ROCK RIDGE ASSISTED LIVING AND MEMORY CARE
AND MEMORY CARE
LOT 1R, BLOCK A,
FLAGSTONE CORNERS
CITY OF ROCKWALL
ROCKWALL COUNTY, TEXAS

GRADING PLAN AREA DETAILS

DRAWN: SRH
DATE: 11/27/12
HEI #: 12-112
SHEET NO: C5.1

DETAIL "D"
1"=20'

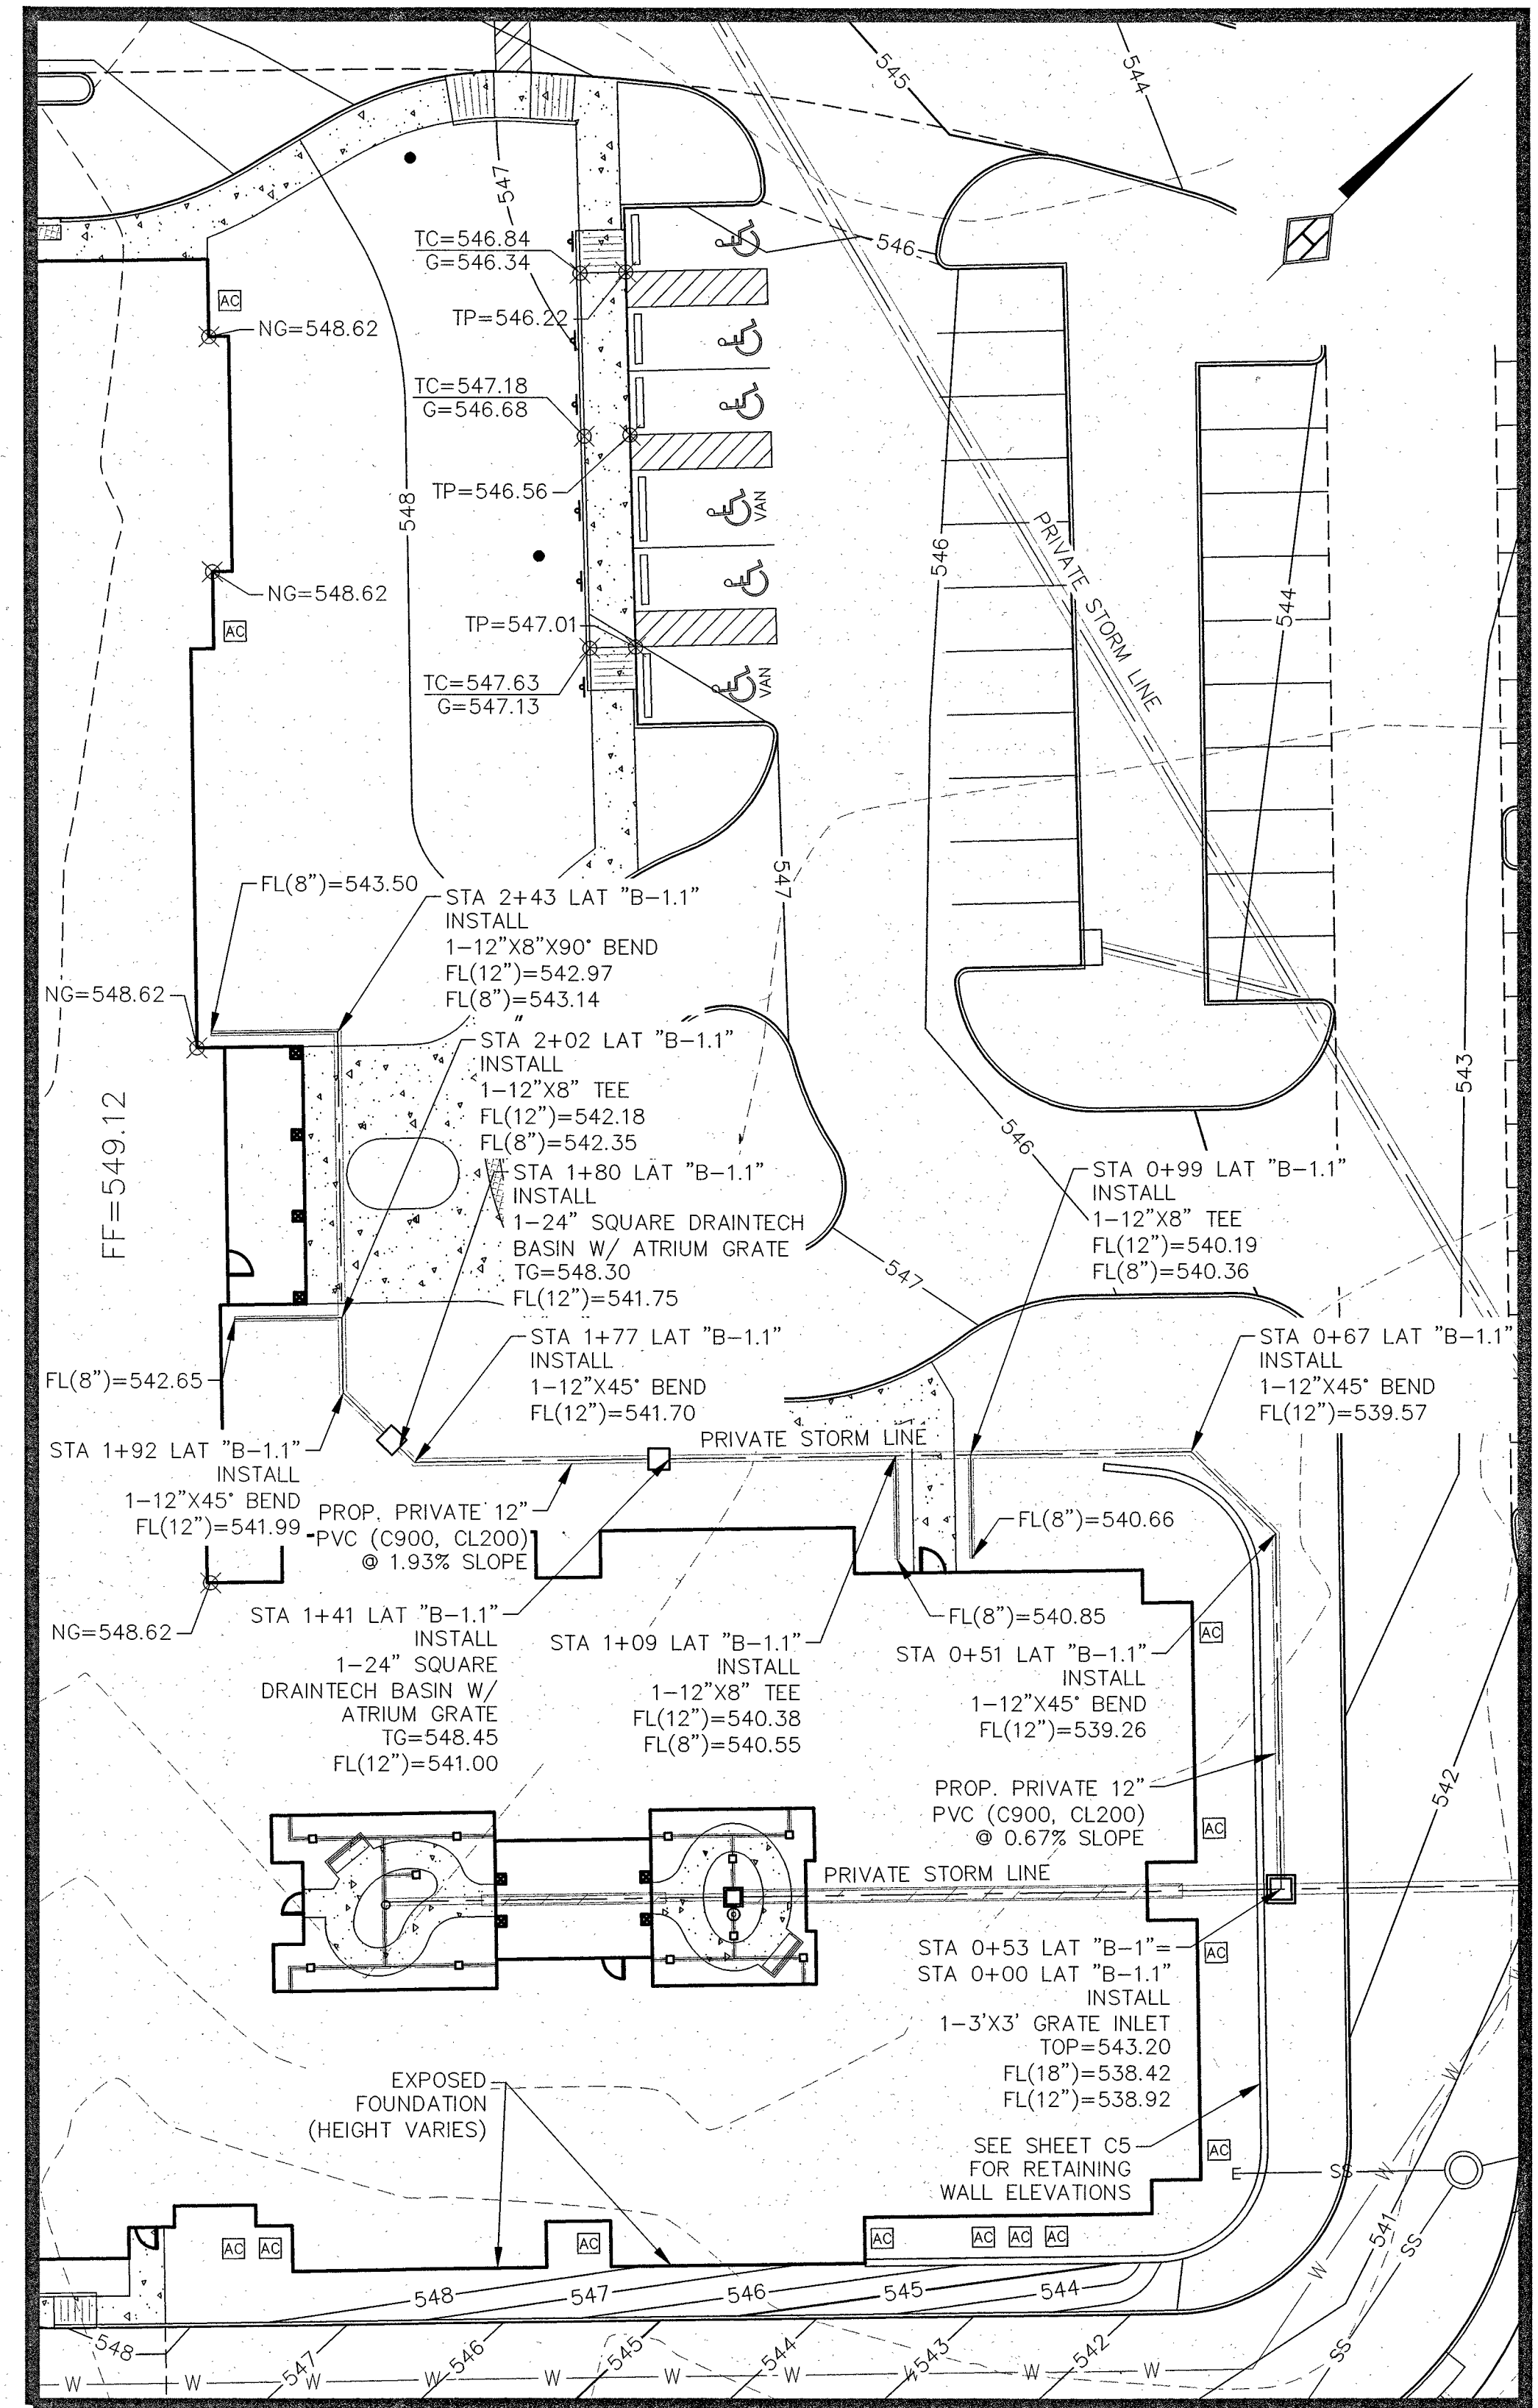
- 07/05/13 REVISED GRADING IN LOADING AREA FOR PROPOSED ACCESSIBLE ROUTE (ADDED DETAIL F)
- REMOVED SIDEWALK ON NORTHEAST CORNER OF BLDG AND REVISED GRADING
- 12/02/13 REVISED GRADING FOR LEAD SIDEWALK CONNECTION TO PUBLIC SIDEWALK PER CONTRACTOR (DETAIL "D")
